RCA VICTOR

MODELS 3-HES-5, 3-HES-5A

Schematic Diagram — RS-146

Chassis No. RS-146, RS-146X

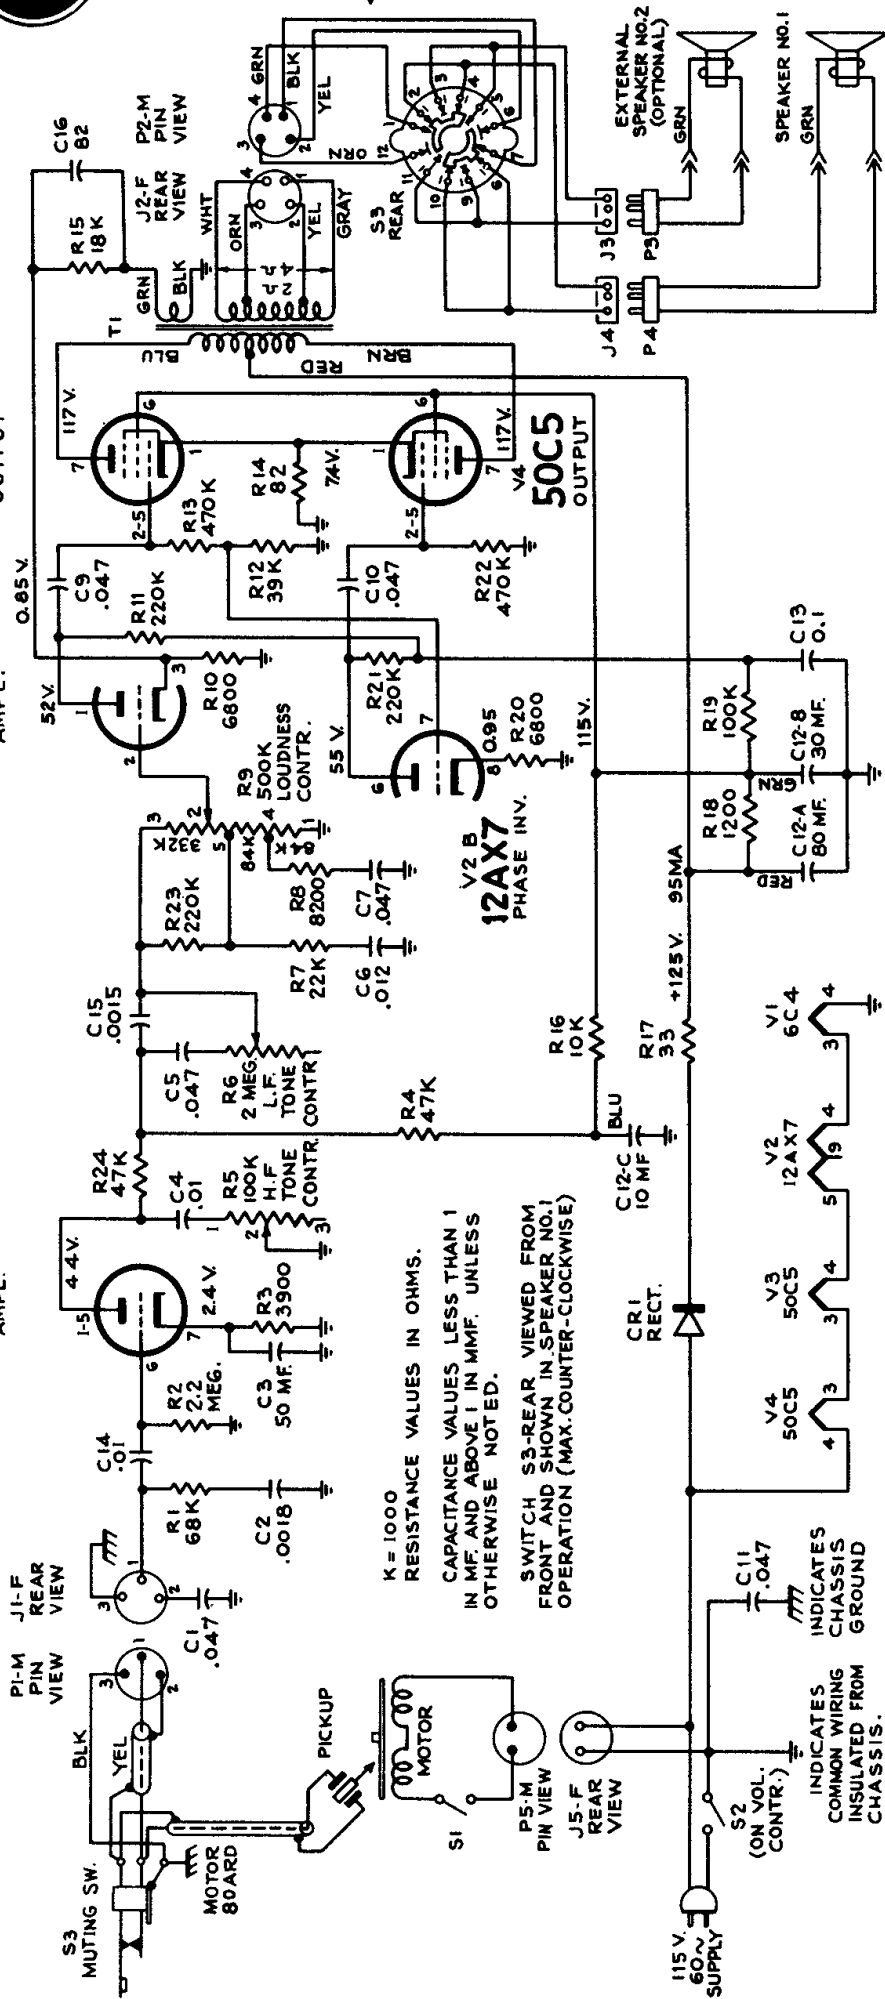
An electrostatic condition has been found to cause an accumulation of metallic dust and minute cuttings between the loudness control terminals and the chassis apron. This causes a partial short circuit and has been found to be the cause of a hum which is difficult to locate. Late production chassis have a coating of black insulating paint at this point.

The loudness control should be examined when any of these chassis are serviced. This space may be cleaned with an air blast or with a soft brush.

The three-section electrolytic capacitor used in this chassis is of a specially selected type of construction. If replacement should be made with other than the specified replacement part (Stock No. 78617), excessive hum may be present. This hum may be due to excessive coupling between sections. If such should be the case, it is advisable to use a separate capacitor for C12C.
